Access Compliance Report

Public Rights-of-Way

(Pedestrian Signals)

Intersection ID: N/A	Main Street:	Cross Street: N/A	Location: N/A
ADA ID: 4C19A5DDF156	Signal Type: One Push Button-Non APS	Overall Compliance: No	Severity Score: BTN 1: N/A BTN 2: N/A No BTN: N/A
Codes/Mitigation Info/Possible Solution		Field Measurements/Component Compliance

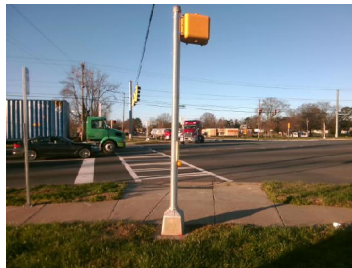
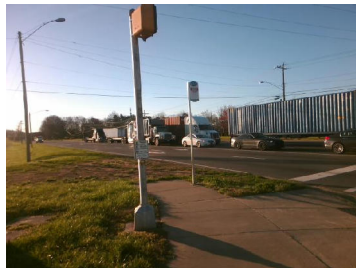
PROW/ADA: TMUTCD 4e.08, R404.2, R404.7.2

N/A	B 1 Clear Xing Direction?	Yes	N/A	B 2 Clear Xing Direction?	N/A
	B 1 Crossing Direction	To SW		B 2 Crossing Direction	N/A
Yes	B 1 DistanceTo XWalk (in)	0.0	N/A	B 2 DistanceTo XWalk (in)	N/A
No	B 1 DistanceTo Curb (in)	173.0	N/A	B 2 DistanceTo Curb (in)	N/A
Yes	B 1 Diameter (in)	2.0	N/A	B 2 Diameter (in)	N/A

Possible Solutions: Replace Signal Push Button With APS Button on New Post. Remove & Relocate Sign.
